SECTION 4.55 APPLICATION
33 UPPER CLIFFORD AVENUE
LOT C DP 102834 FAIRLIGHT
DA166/2015

S4.55 APPLICATION DRAWING LIST

DEVELOPMENT CONSENT DA-166/2015
NORTHERN BEACHES COUNCIL
DEVELOPMENT MODIFICATION MOD2018/0715
BASIX CERTIFICATE No A336197_03

S4.55 APPLICATION
ADDITIONS & ALTERATIONS
33 UPPER CLIFFORD AVENUE
FAIRLIGHT

03 DA APPROVED - WEST ELEVATION
scale 1:100

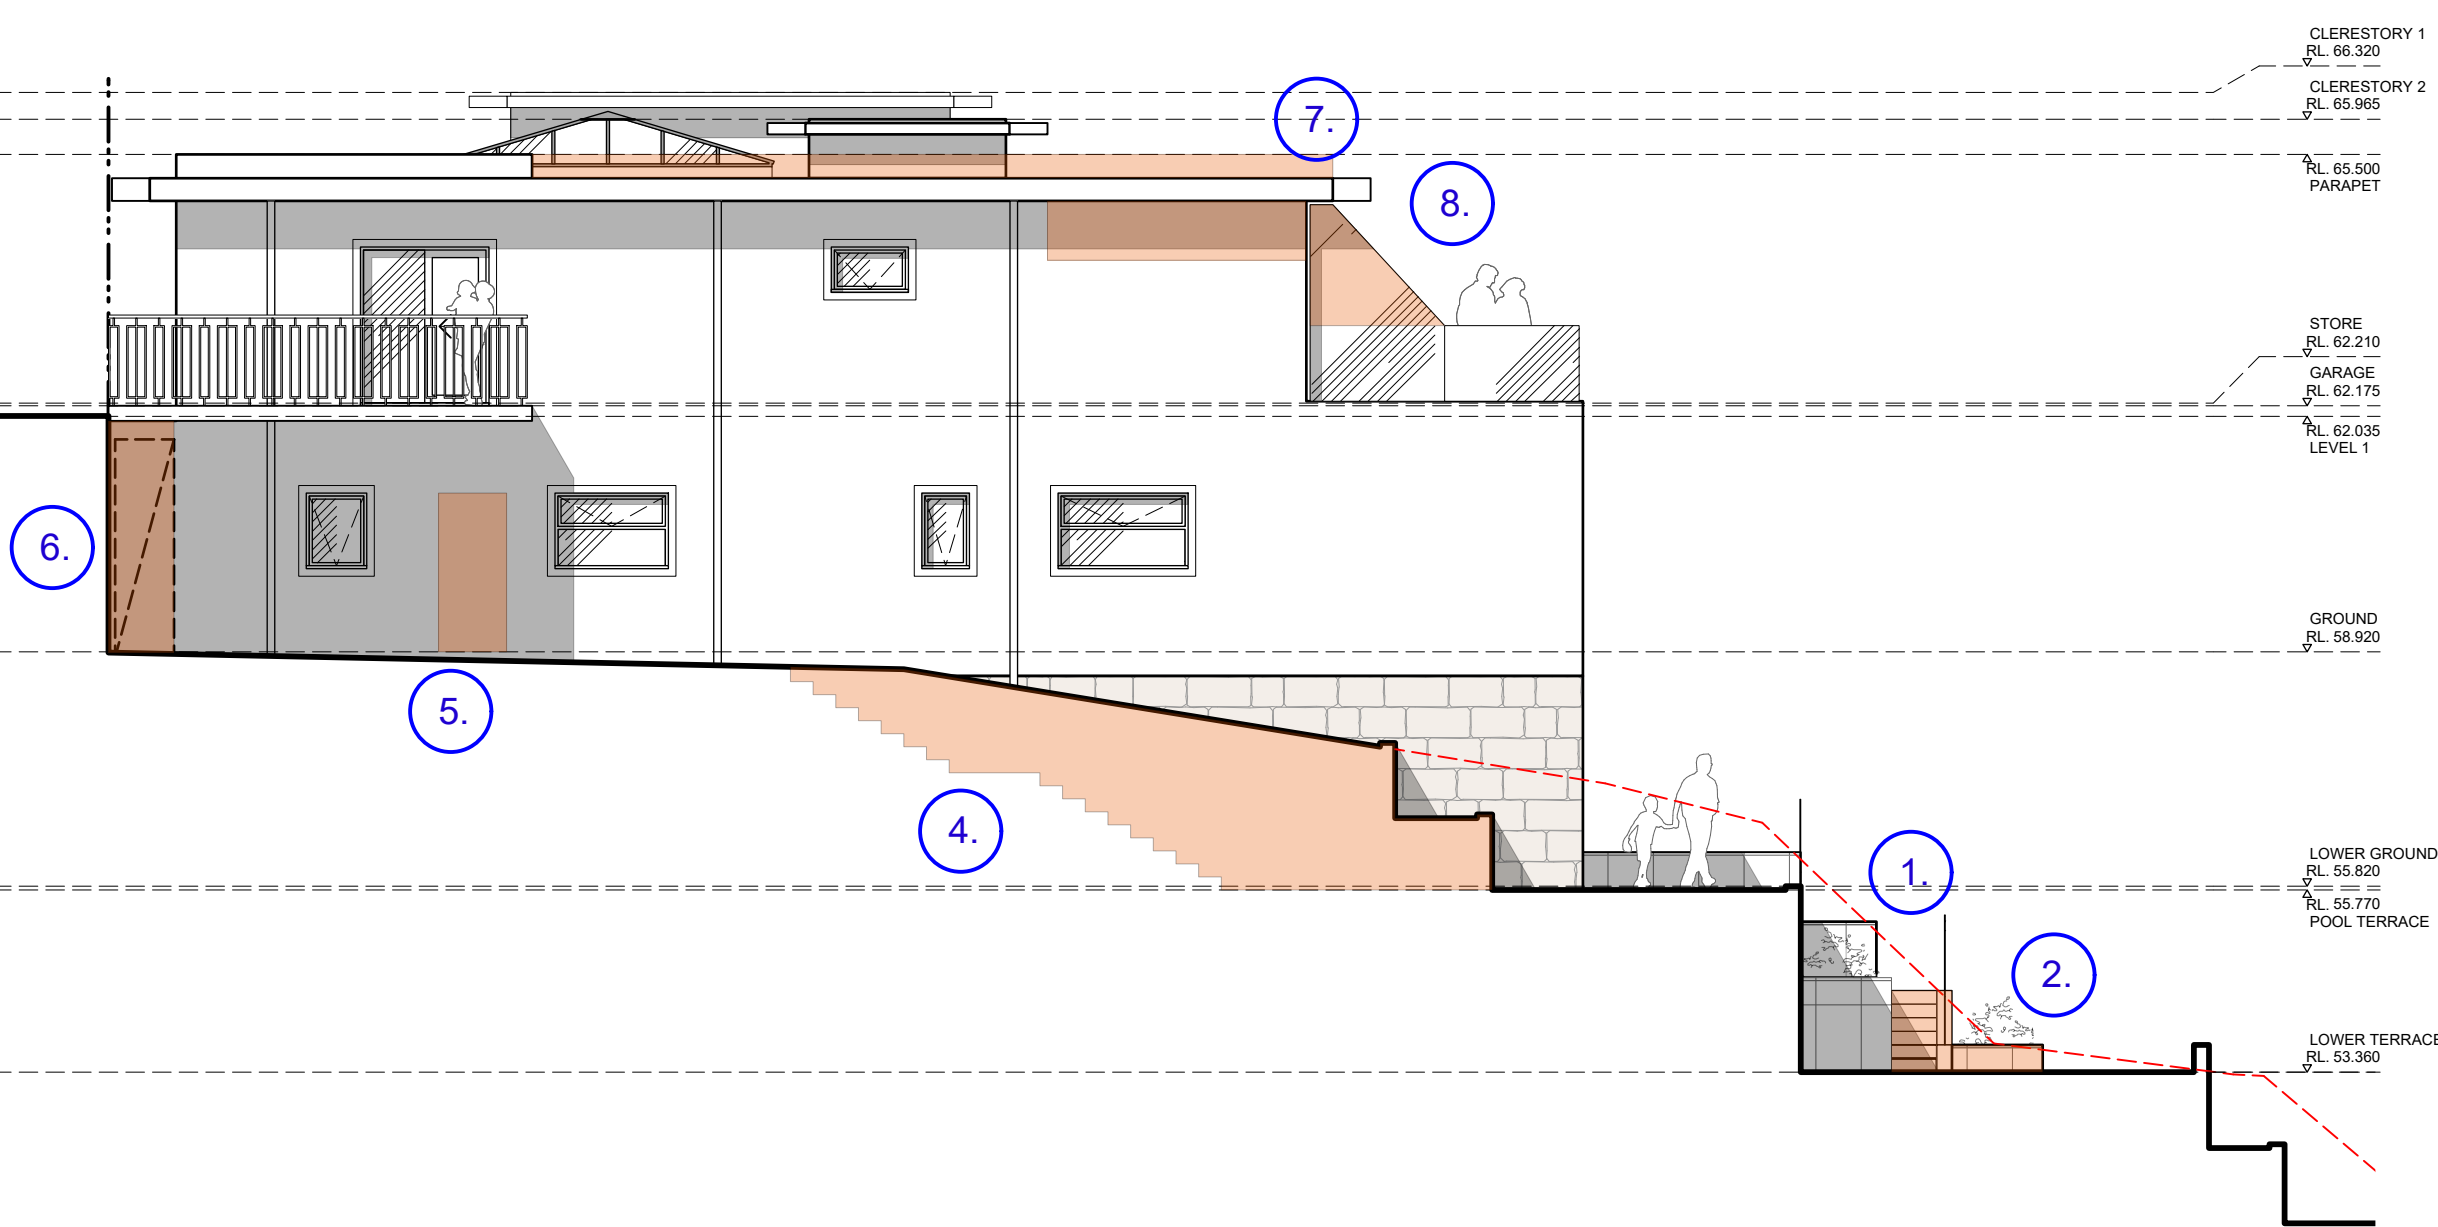
1. ADDITION OF LEVEL CHANGE TO TERRACE PATHWAY
2. MINOR CHANGE TO RETAINING WALL
3. REMOVE MASTER WIR WINDOW AWNING
4. REMOVE WESTERN STAIR ACCESS
5. REMOVE EXTERNAL ACCESS FROM BED 2
6. RELOCATE RAIN WATER TANK
7. UPDATE ROOF DESIGN TO COMPLY WITH PREVIOUS S4.55 CONDITIONS - REMOVE PART OF PARAPET
8. UPDATE BALUSTRADE DESIGN TO PREVENT POTENTIAL CLIMBABLE SURFACE HAZARD
